OBERHEIM ELECTRONICS, INC.
ENGINEERING CHANGE ORDER

OB-8

SCHEMATIC 1679A SHEET 2

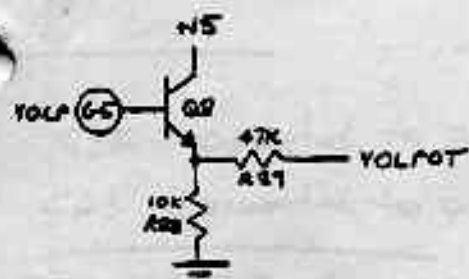
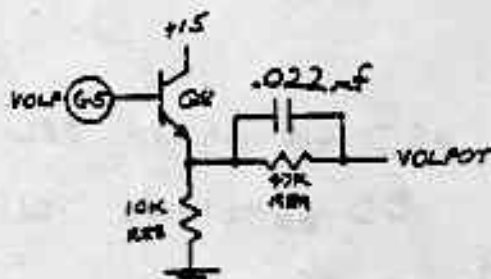
ADD .022uF CAPACITOR IN
PARALLEL WITH 47K.

TO ELIMINATE NOISE WHEN CONTROLLING THE VOLUME WITH
AN EXTERNAL LOW IMPEDANCE VOLTAGE SOURCE.

OB-8 POT. Board 1&2 1681A C

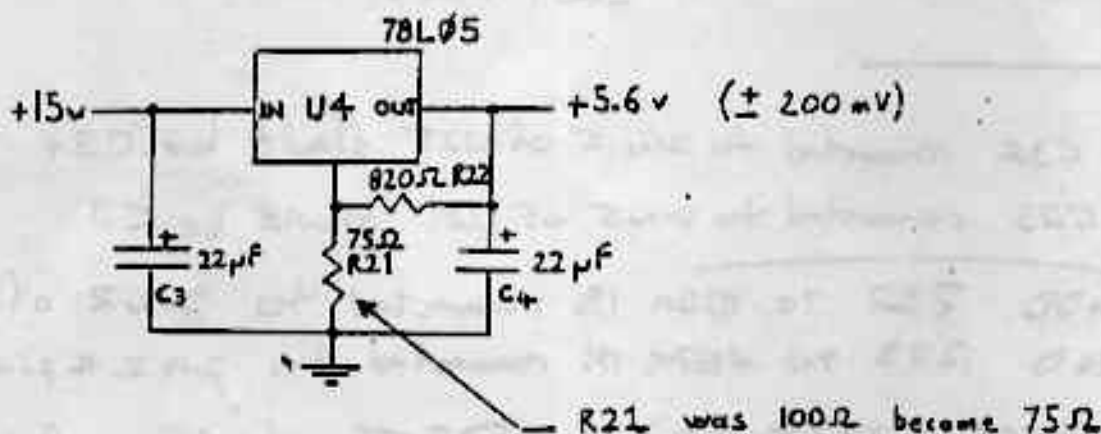
Reduce output of 5.6v Supply.

Increase the active range of the Front panel pots

OB-8 VOICE BOARD 1682A

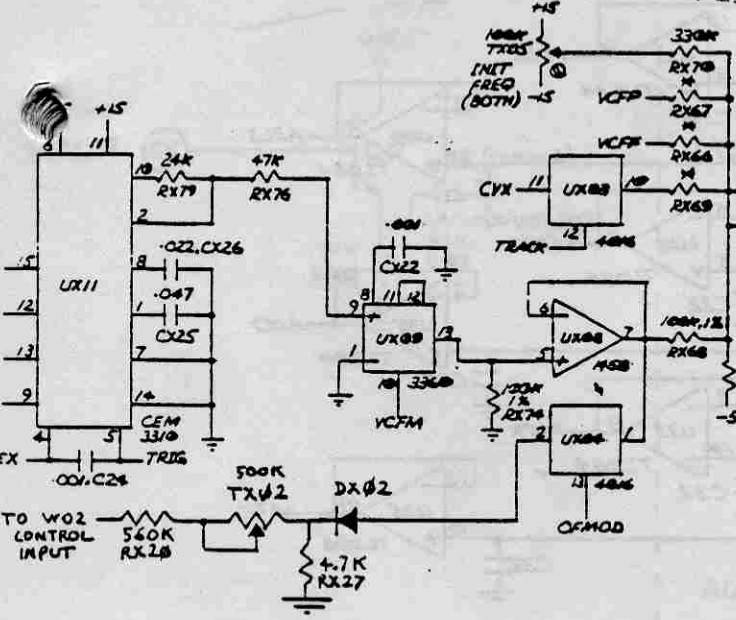
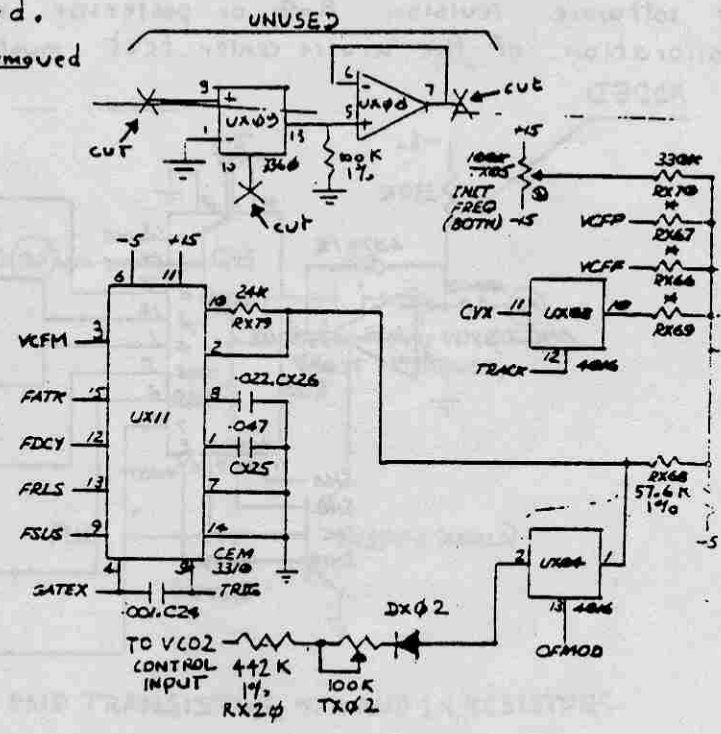
The 3360 VCA is bypassed and the 3310 in conjunction with the software modulates the amplitude of the envelope. A software revision A-4 or posterior must be installed.
331, at the output of U27 is short circuited & R30 is removed (see sheet 2)

Improve temperature stability and tracking of VCO2 Filter env. modulation

OB-8 VOKE BOARD 1682A

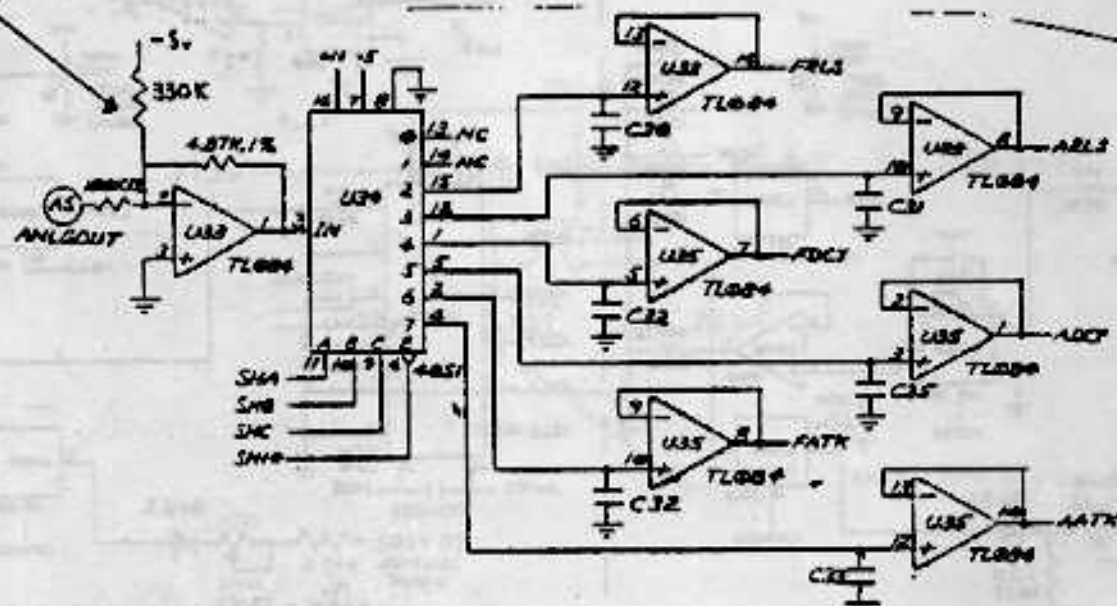
A software revision A-4 or posterior must be installed and the offset calibration of the service center test must be performed.

The offset calibration routine of the service center test can correct the TL084 for positive or negative offset.

SCHEMATIC 1679 A, SHEET 2
OB-8 PROCESSOR BOARD

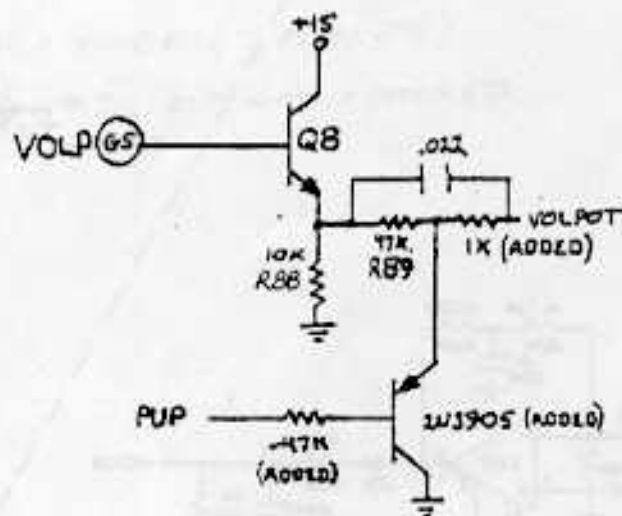
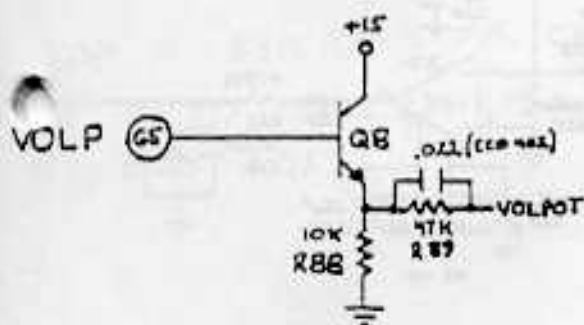
ADD PNP TRANSISTOR, 47K AND 1K RESISTORS

TO REDUCE POWER-DOWN GLITCH AT OUTPUTS

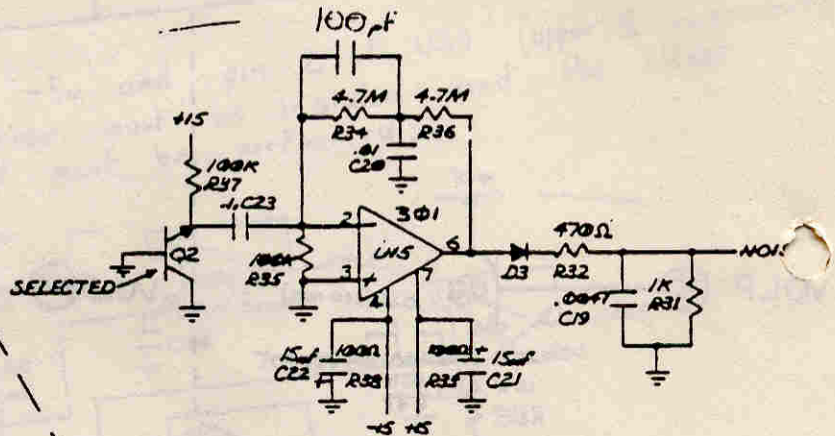
ADD A 100pF CAPACITOR
IN PARALLEL WITH R34

ON REVISION A PROCESSOR BOARDS, WHEN A SEQUENCER IS CONNECTED,
DISTORTION BECOMES PRESENT IN THE NOISE GENERATOR.

OB-8 BEND BOX 1680A SHEET 1 OF 1

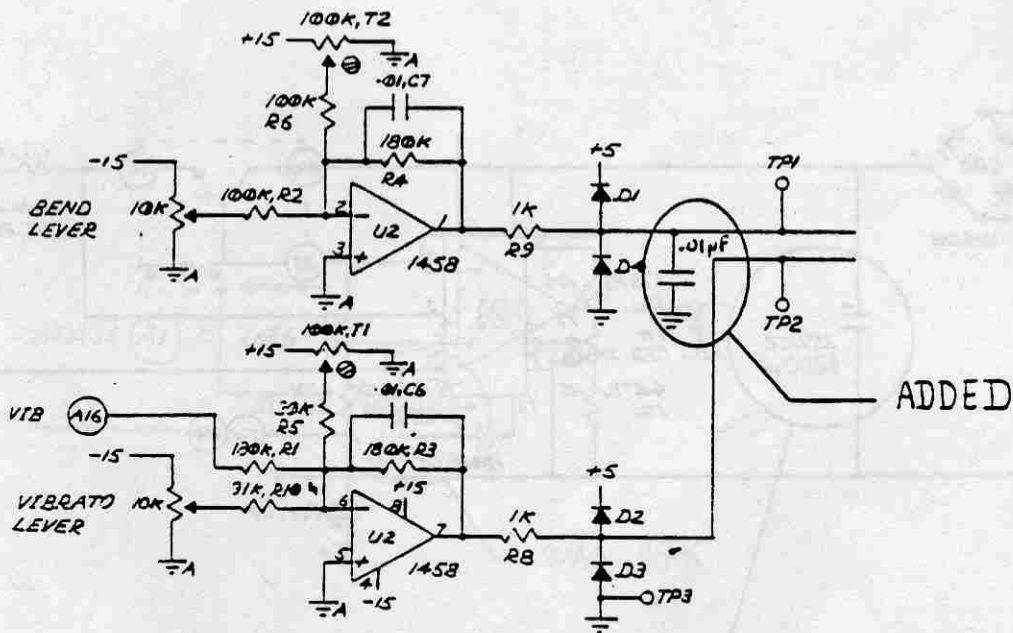
- REMOVES NOISE MODULATION FROM BENDER LEVER

PROCESSOR BOARD- POWER SUPPLY
1679A SHEET 4 of 4

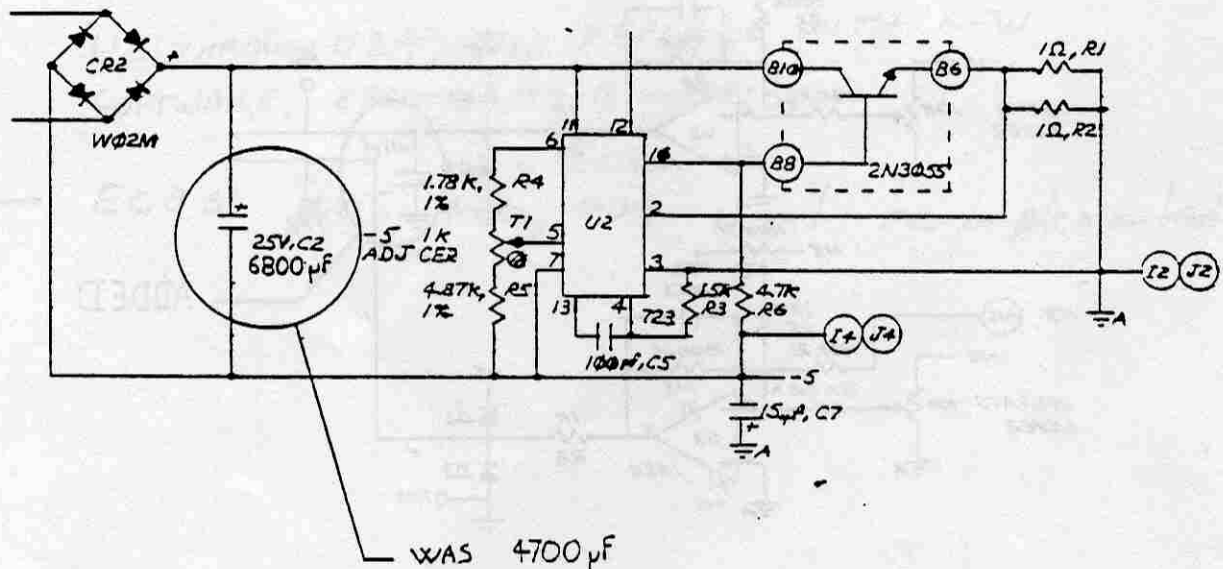
(REFERENCE ECO #401)

WHEN THE NEW POWER SUPPLY TRANSFORMER (REF. 561021) IS USED, THIS CHANGE DECREASES THE OUTPUT THUMP ON POWER OFF.

VOICE BOARD 1682A SHEET 2 OF 3

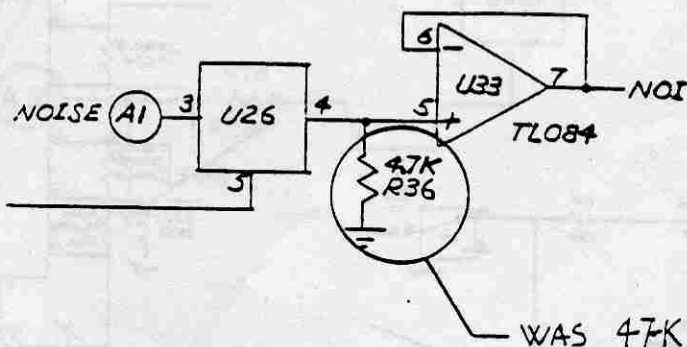
REMOVE LEAK OF NOISE GENERATOR WHEN A VOICE IS GATED

2 POLE/4 POLE CONFIGURATION

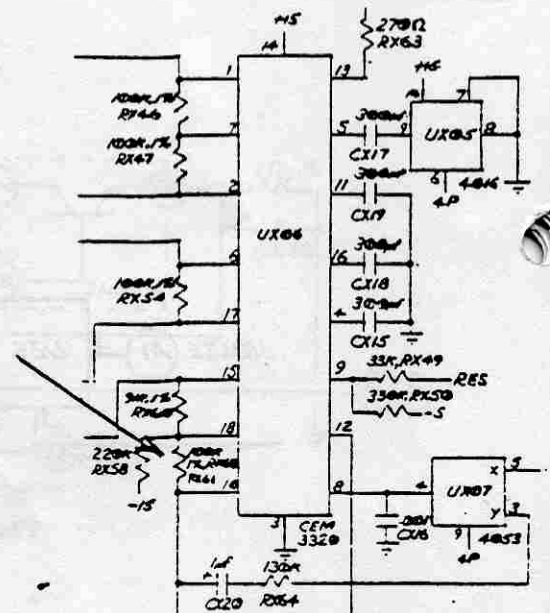
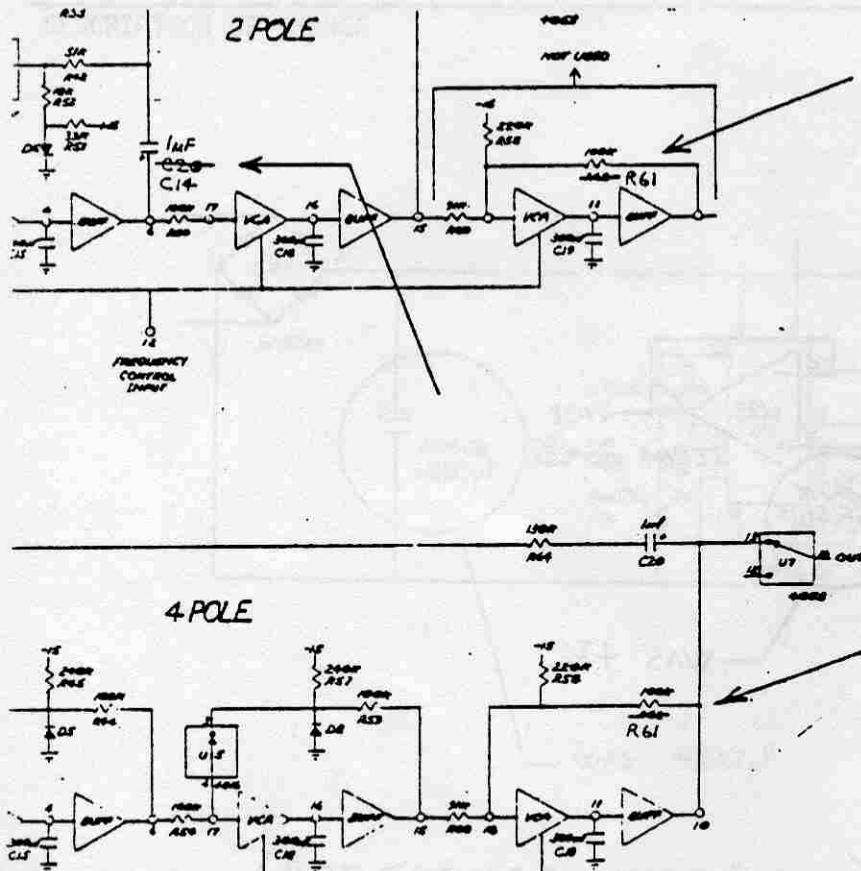
RESISTOR AT UX06 PINS 10, 18 MARKED RX68 SHOULD BE RX61.

CAPACITOR IN 2 POLE/4 POLE CONFIGURATION DRAWING MARKED C20 SHOULD BE C14.

1682 B OB-8 VOICE BOARD (UPPER)

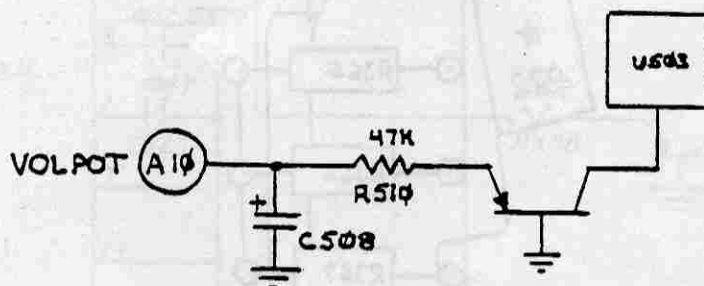
Change C508 from 0.1 μ f Mylar To 2.2 Electrolytic (Upper Voice only)

To eliminate noise at output at low master volume levels

1632 B OB-8 Voice Board
1639 B

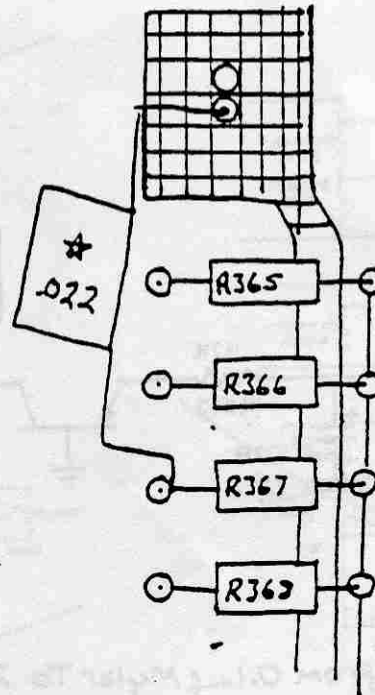
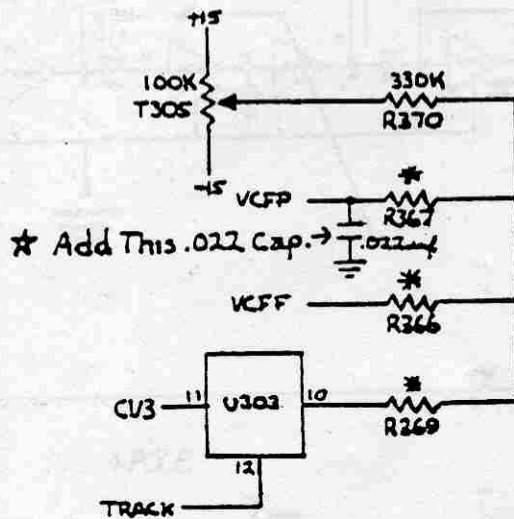
Add a .022 Mylar Capacitor To both The Top and bottom Voice Boards

To Filter-out digital noise picked up along The Filter Pedal line (VCFF) when a Sequencer (05X) is connected.

OB-8 VOICE BOARD 1682 B SHEET 3 OF 3

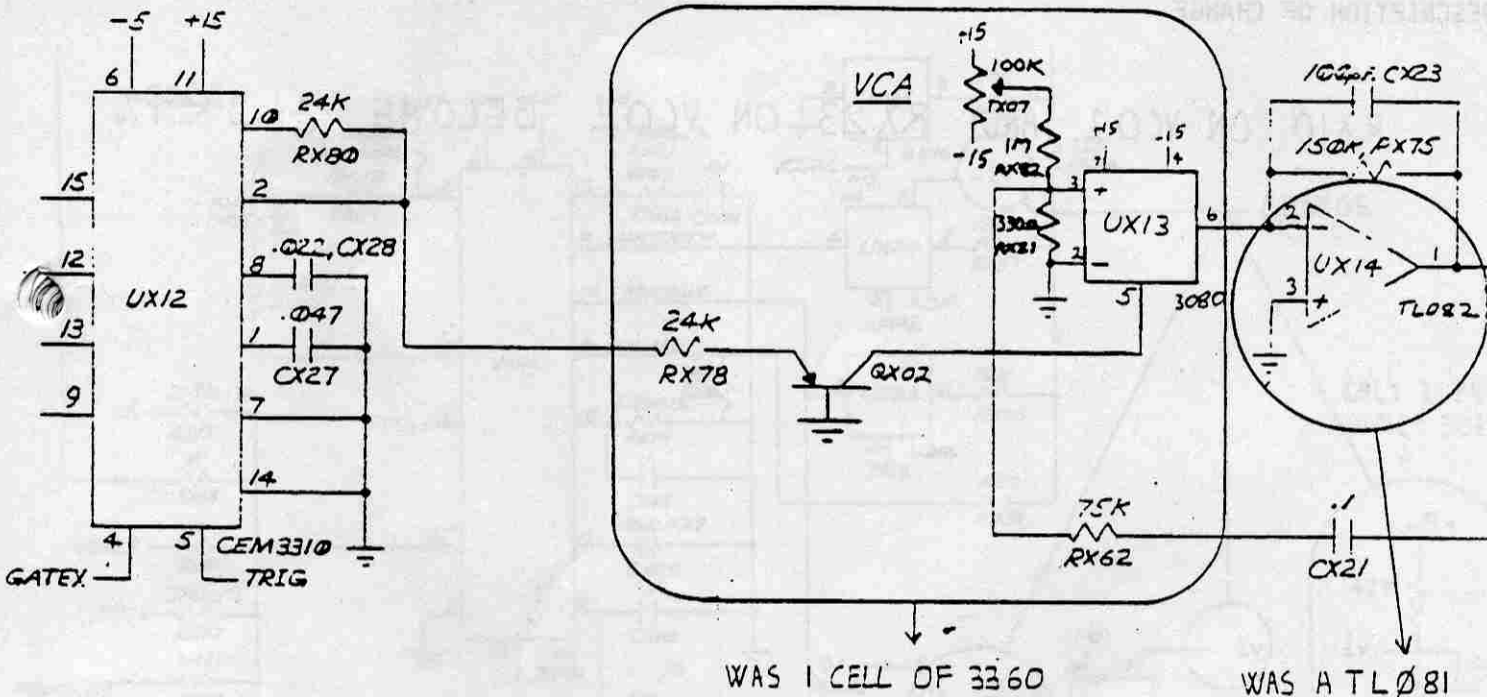
— ALSO: UX08 IS DELETED AND REPLACED BY THE OTHER CELL OF THE TL082 UX14

— RATIONALIZE THE CIRCUITRY

OB-8 VOICE BOARD 1682A SHEET 3 OF 3

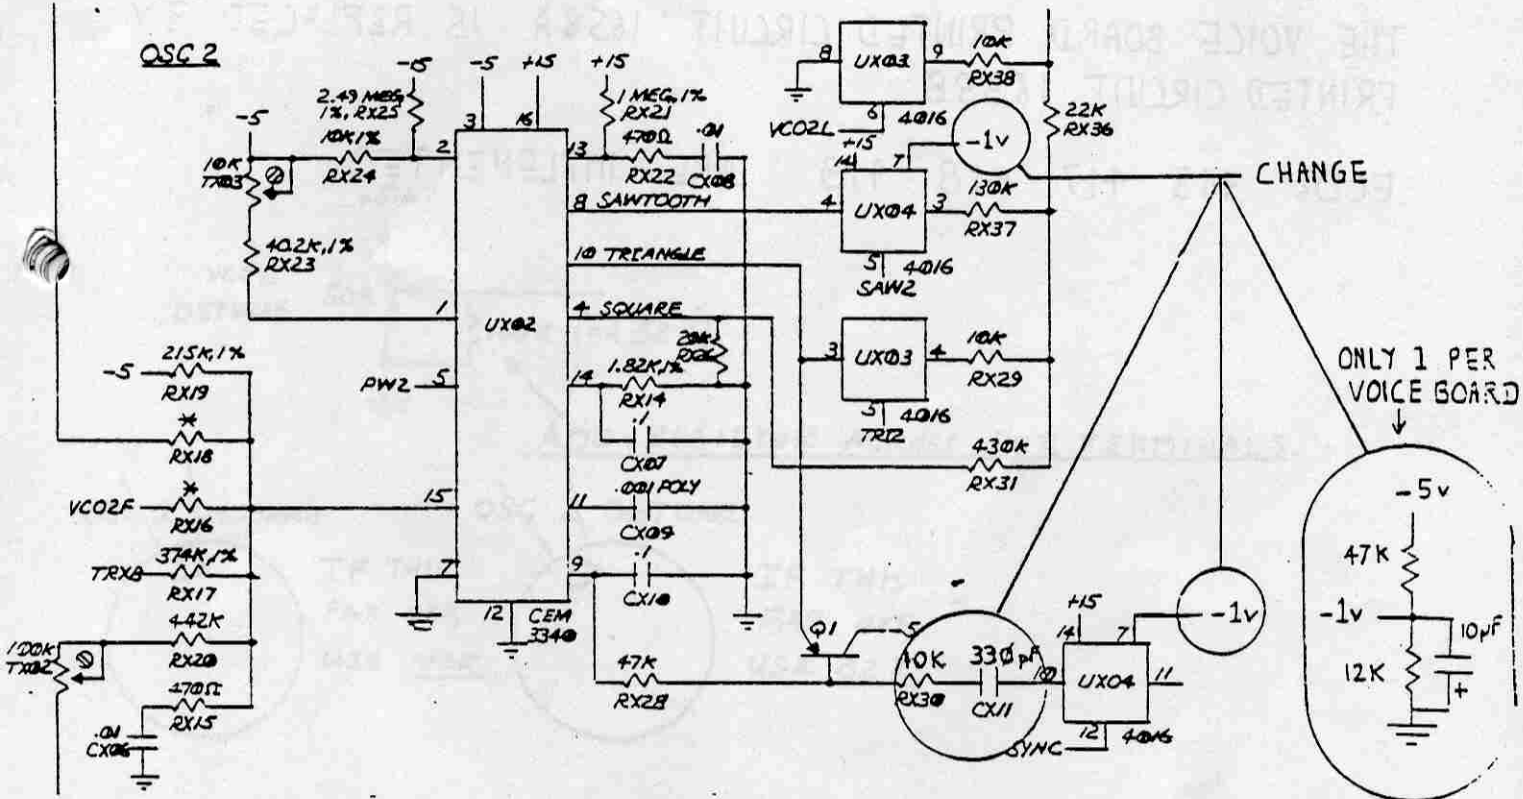
- IMPROVES SYNCHRO SOUND

1681 B

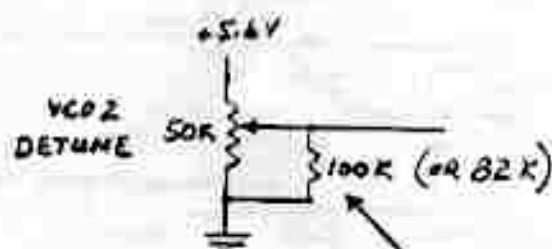
ADD RESISTOR ACROSS POT. TERMINALS.

IF THIS
FAR OFF,
USE 100K

IF THIS
FAR OFF,
USE 82K

TO CENTER OSC 2 DETUNE CONTROL WHEN LED GOES OFF
WITH KNOB SIGNIFICANTLY COUNTERCLOCKWISE OF CENTER.

OB-8 VOICE BOARD 1682B SHEET 2

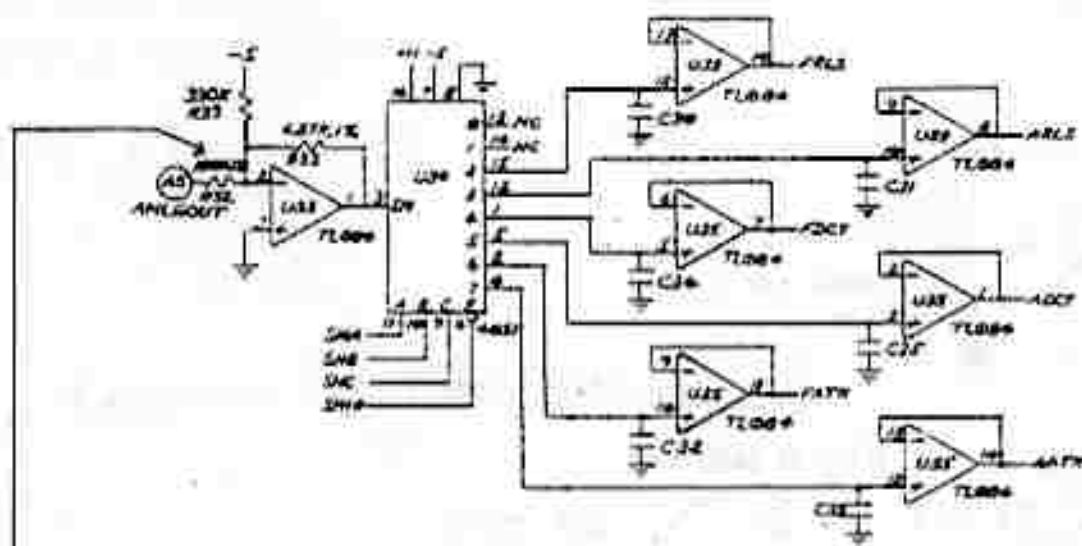
R32 100K 1% are 50Ω matched between Lower and upper Tray.

R32 on the Lower and upper tray are mounted after the two boards are screwed together.

—IMPROVES MATCHING OF TIMING BETWEEN ENVELOPES OF UPPER, AND LOWER TRAY.

1679 B - SHEET 1

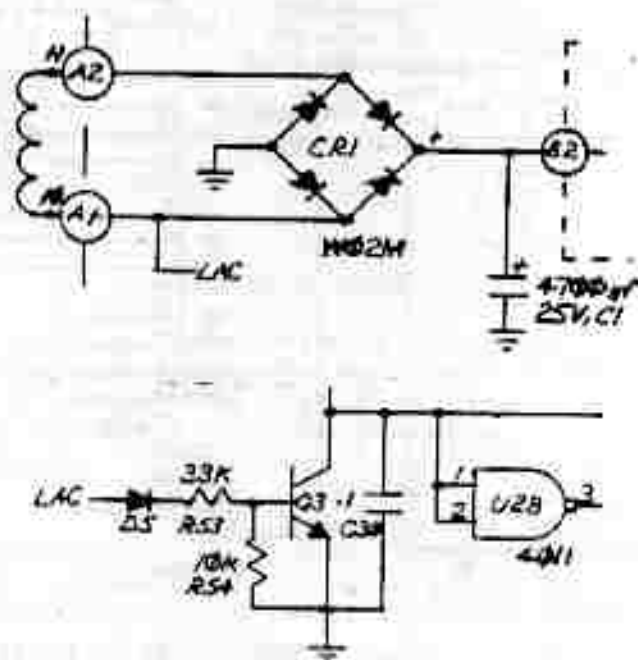
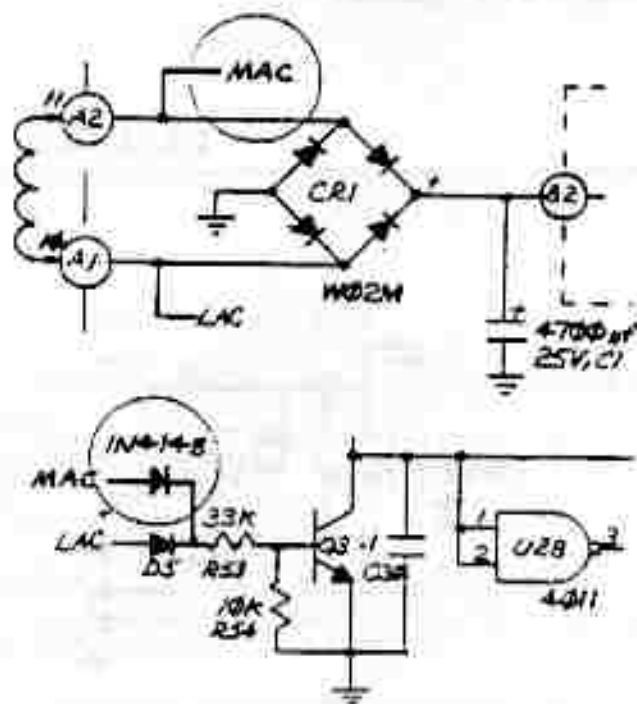
IMPROVE MARGIN OF "PUP" CIRCUIT TO INADVERTENT TURN-OFF, ESPECIALLY AT 50 KHz.
